North Little Rock Planning Commission
February 13, 2024 - Agenda / Public Hearing 4:00 PM
City Council Chambers – 300 Main Street, NLR, AR 72114

Planning Commission Hearing Items:

SD2023-67 The Grove Add Preliminary Plat located near Plantation Lake Dr and Craig Rd (18 lot single family prel plat)

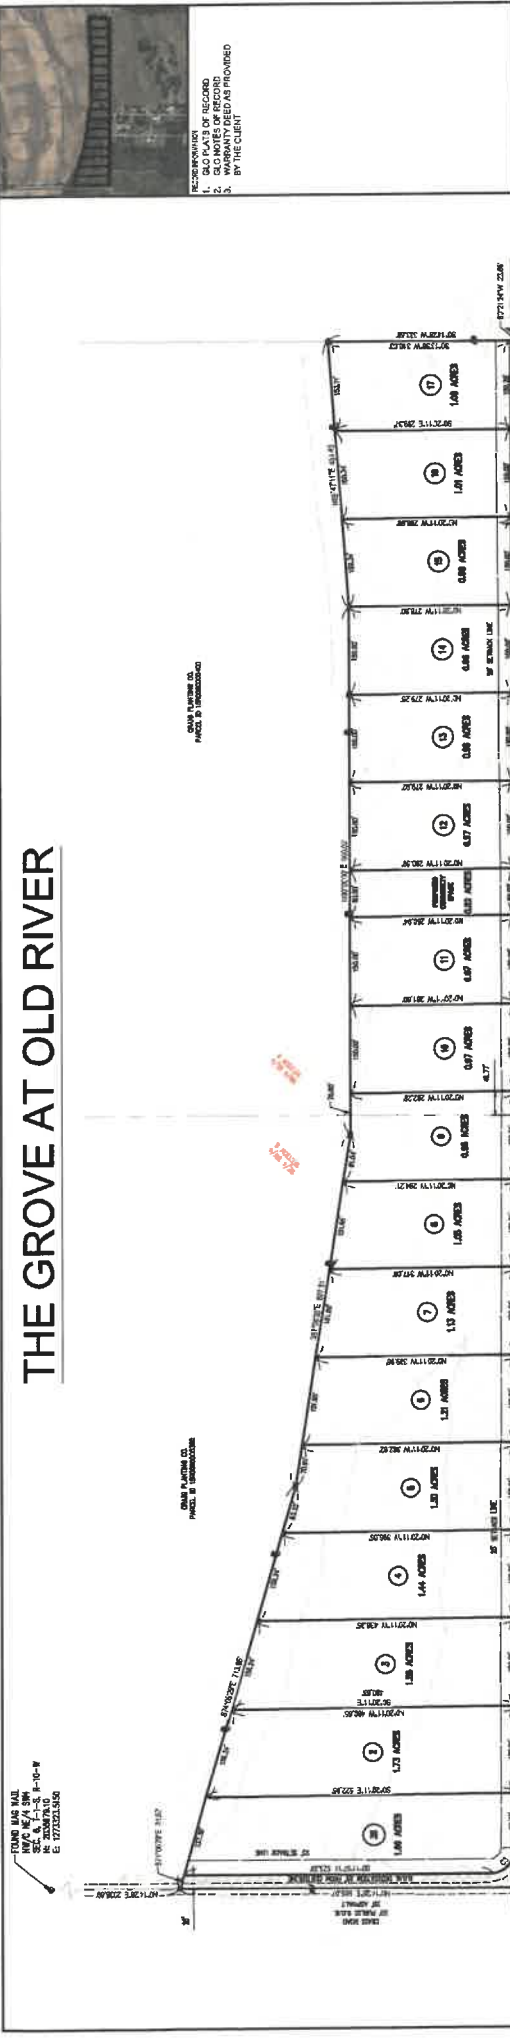
- a. Provide on-site stormwater detention as well as clear calculations showing that detention volume is sufficient, or demonstrate to City Engineer that on-site detention is not required (based on proposed development) by providing detention calculations showing pre and post site runoff comparisons (*OR*) Option to pay the drainage in-lieu fee of \$5000/acre for commercial/industrial development or \$500/acre for residential development instead of providing on-site detention.

- b. Provide full street improvements (street, drainage, curb and gutter, sidewalk, cross walks) or a performance bond. Street improvements must be approved by City Engineer and accepted by City Council.

- c. Provide 25' property line corner radius.
 - d. Meet all City of North Little Rocks Standard Specifications.
3. Planning requirements before the plat will be signed:

- c. Provide (25') ROW dedication along Craig Rd as shown on the plat.
 - d. Provide 10' utility easements around property perimeter.
4. Meet the requirements of Permits & Planning, including:

- b. Provide ROW dedication per the Master Street Plan along Craig Rd.
6. Meet the requirements of the Screening and Landscaping ordinance, including:
 - a. All disturbed areas are to be sodded, fertilized, watered and mulched.

- a. Provide an approved fire protection plan.
 - b. Meet the requirements of the 2021 Arkansas Fire Prevention Code including:
 - i. Where there are houses, fire hydrants shall have an average spacing of 500' along streets. The maximum distance from any point on a street frontage to a hydrant shall be 250'.
(Volume 1 Appendix C Table C102.1)

- a. Provide Bill of Assurance.
 - b. Pay \$50.00 review fee.
 - c. Provide Volunteer Fire Department approval.
 - d. Provide ADH subdivision approval.
 - e. Provide a letter from Grand Prairie Water stating water service will be provided.

- f. Obtain driveway permits from PCRB for all new driveways.
- g. Clarify NLR requirements whether this is a preliminary or Final Plat.
- h. Comply with any City of NLR Right of Way and street improvement requirements.
- i. If half-street improvements are required, provide set of construction plans to PC for review and approval prior to construction.
- j. Label the proposed community space as a Tract and include its name on the plat and in the bill of assurance.

SD2024-06 Original Town of Argenta Add Lot 2R, Blk 44, Replat and SPR @ 716 N Olive St (15 single bdrm townhomes)

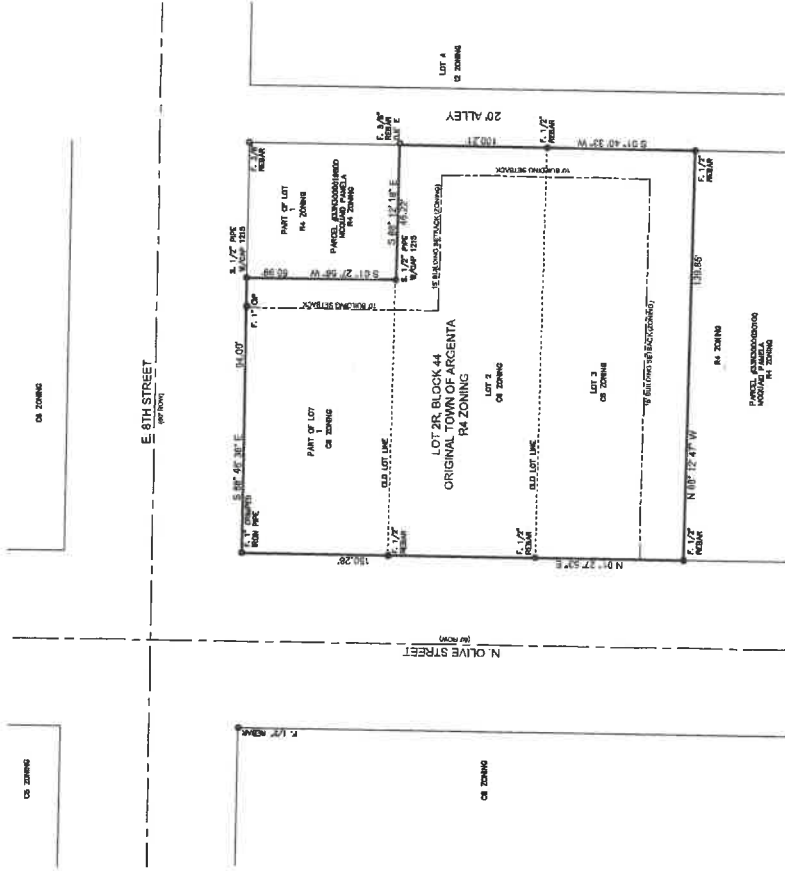
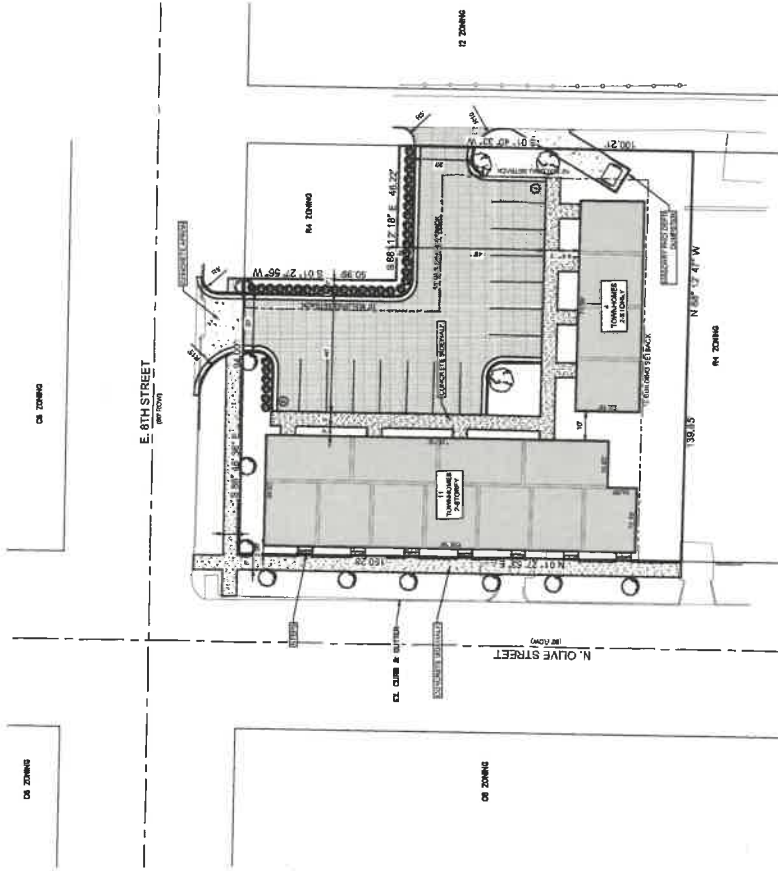
2. Engineering requirements on detention:
 - a. Option to pay the drainage in-lieu of fee of \$5000/acre instead of providing onsite detention. *OR* Provide on-site stormwater detention as well as clear calculations showing that detention volume is sufficient, or demonstrate to City Engineer that on-site detention is not required (based on proposed development) by providing detention calculations showing pre and post site runoff comparisons.

3. Engineering requirements before the plat will be signed:
 - a. Provide half of the required 60' right-of-way.
4. Permit requirements/approvals submitted before a building permit will be issued:

- a. A signed and recorded plat must be on file with the Planning Department.
 - b. Provide CNLR Grading Permit application to City Engineer with grading plans.

- a. The HOA will be solely responsible for maintaining the private sewer service line for the development.
 - b. Please submit a full set of plans to NLRW for review and approval prior to construction.
